**ADDRESS: 305 N FRONT ST**

Proposal: Renovate building; rebuild facades; add deck and pilot house

Review Requested: Final Approval

Staff Contact: Megan Cross Schmitt, [megan.schmitt@phila.gov](mailto:megan.schmitt@phila.gov), 215-686-7660

EAST EXTERIOR  
ELEVATION

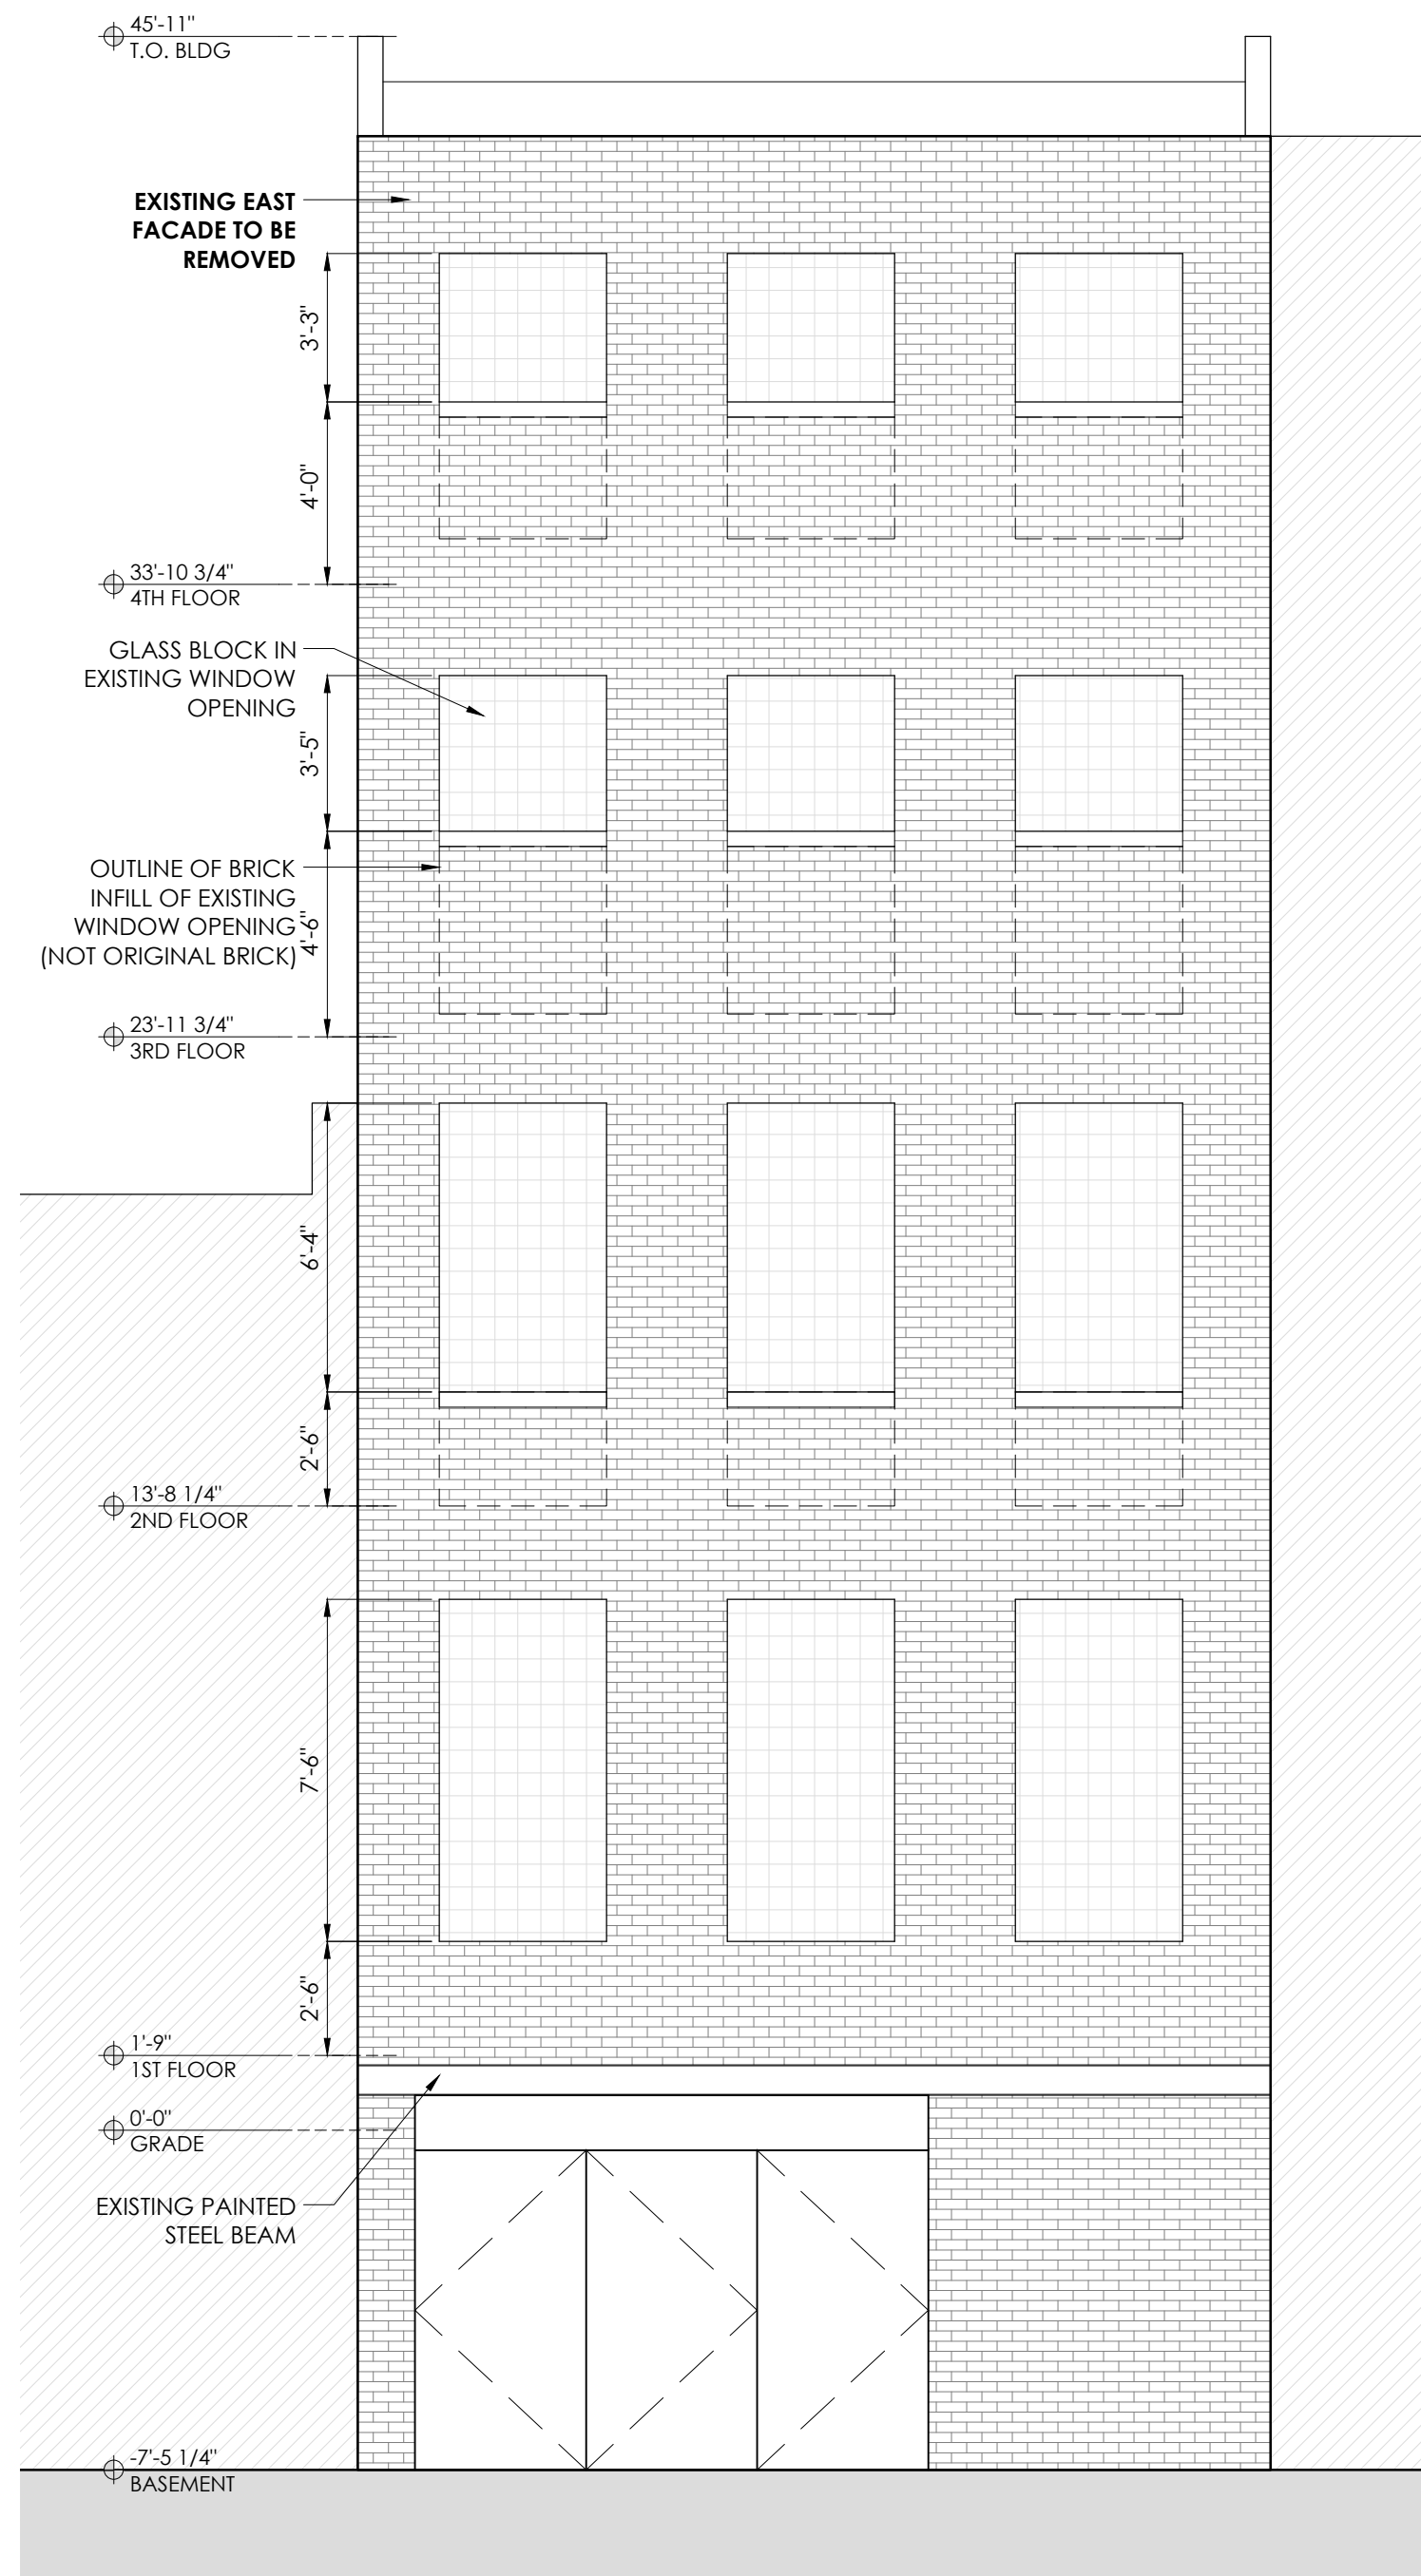
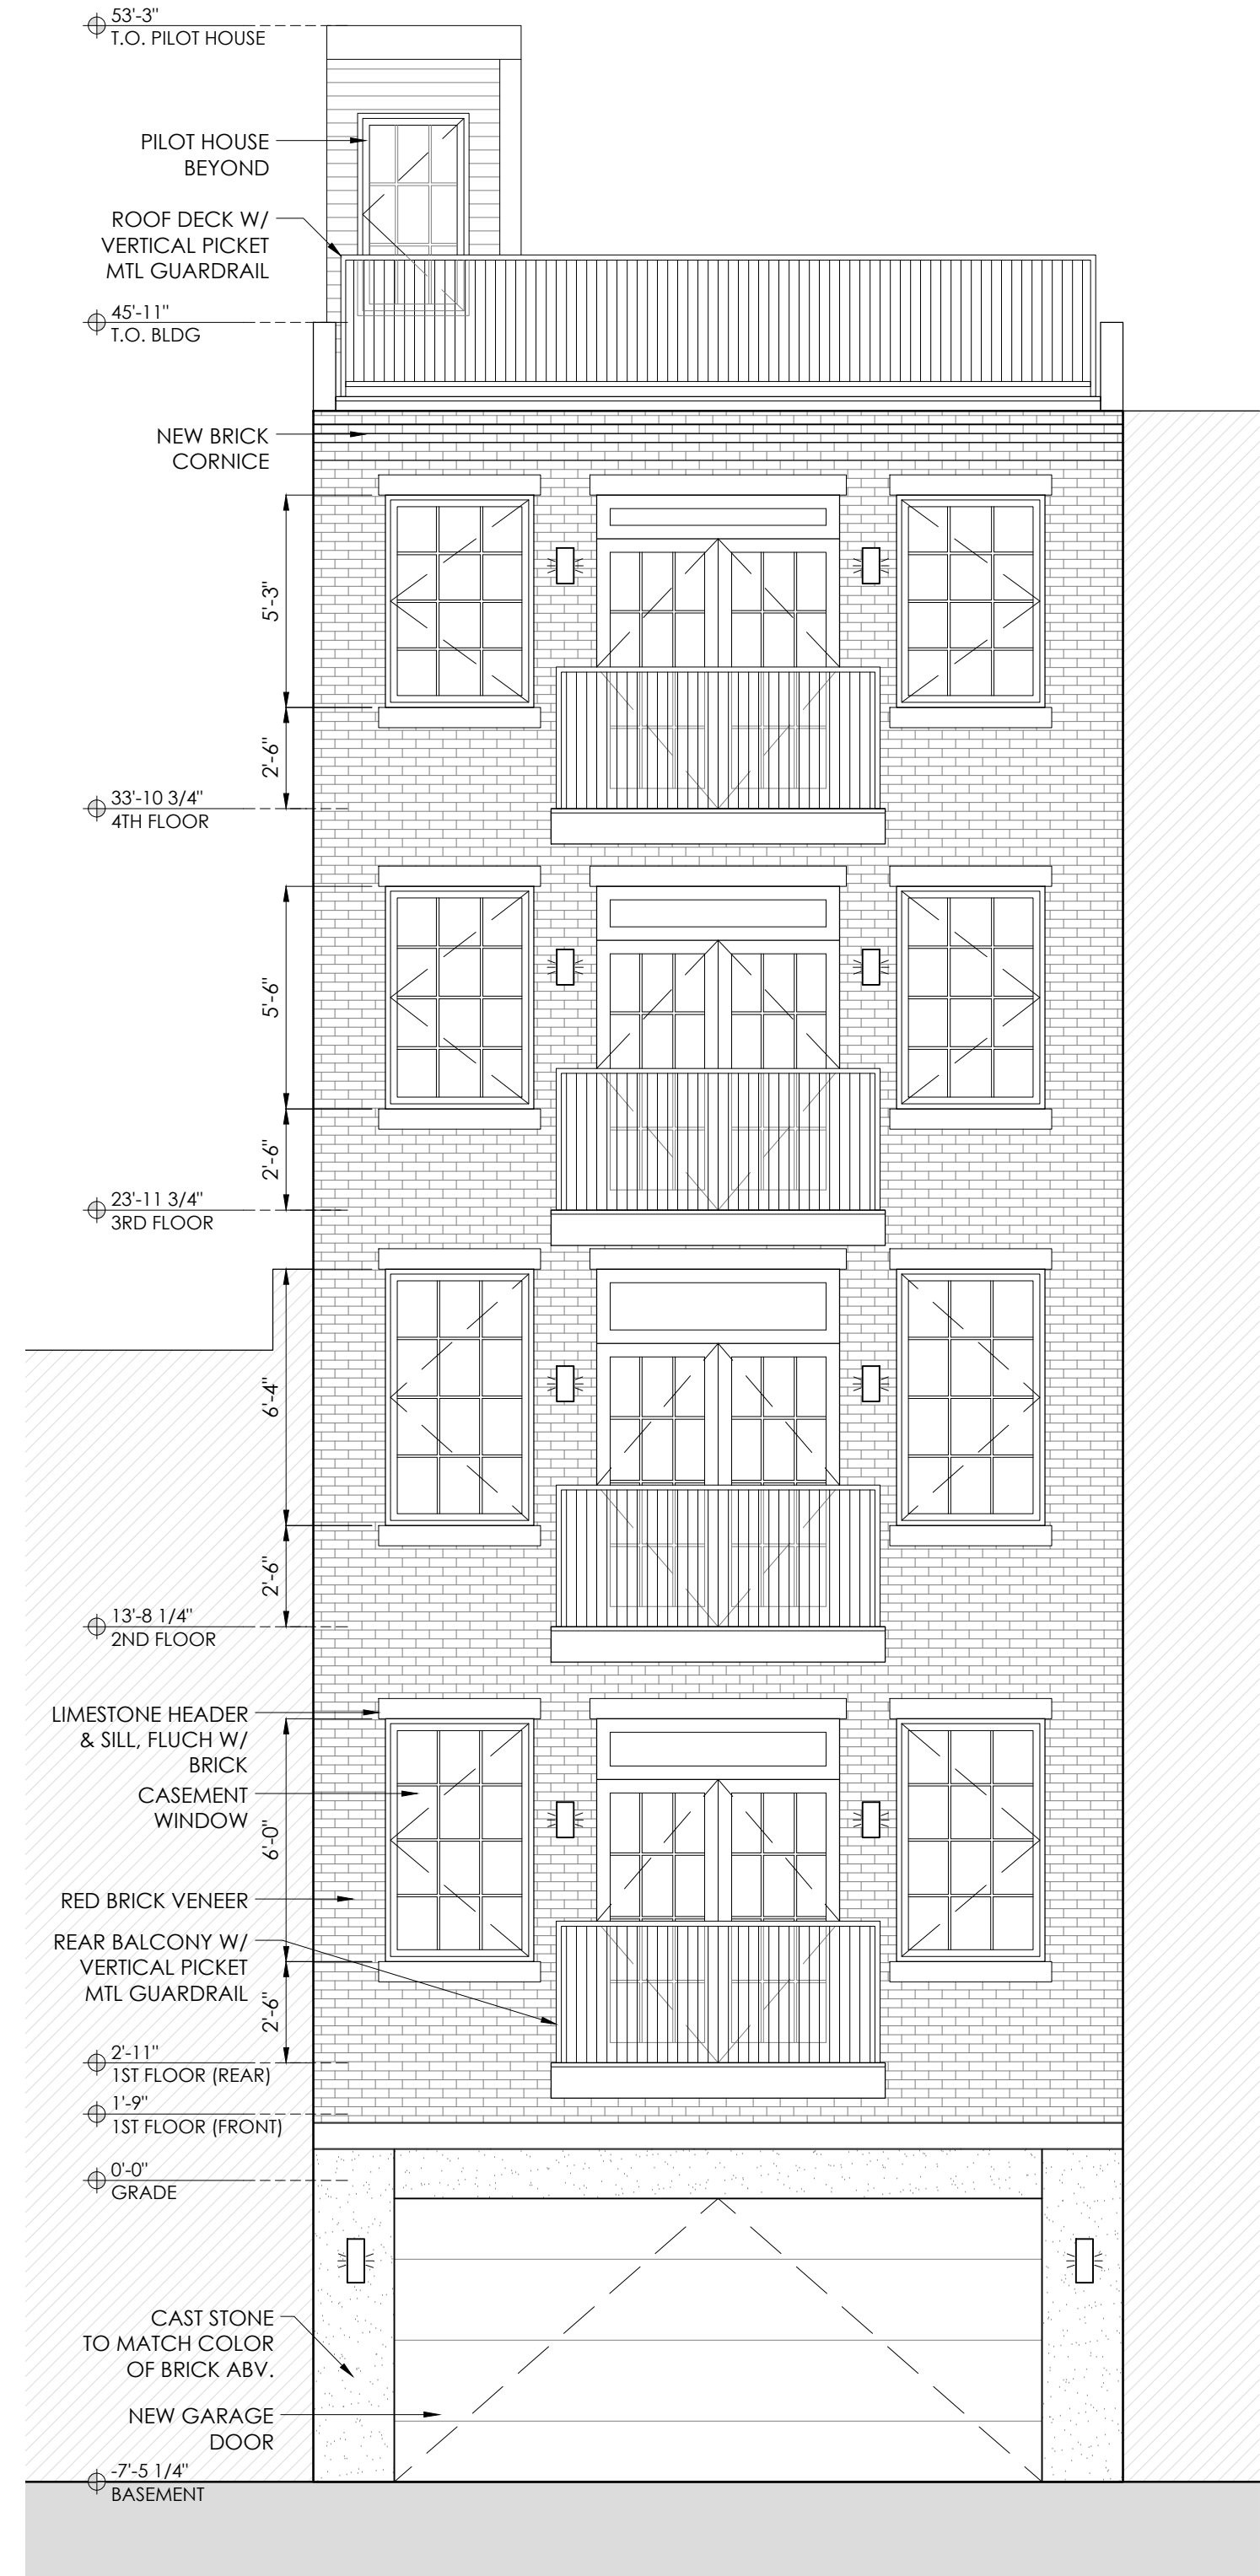
At the N. Water Street elevation, the fenestration pattern is altered from the historic pattern. At stories two through five, balconies with double-doors are proposed at the middle bay, which are flanked by casement windows like the ones proposed for the front. A new garage door with a cast stone surround is proposed at the ground story.

- The extent of the historic brick that is proposed for demolition does not satisfy Standard 9.
- Any historic storefront material that exists beneath the altered N. Front Street façade should be preserved and restored.
- The proposed reconstruction does not reflect existing physical and archival evidence of the building's historic conditions. Given the availability of such evidence, the proposed reconstruction should more closely reflect the historic facades in terms of fenestration, window type, and façade materials.
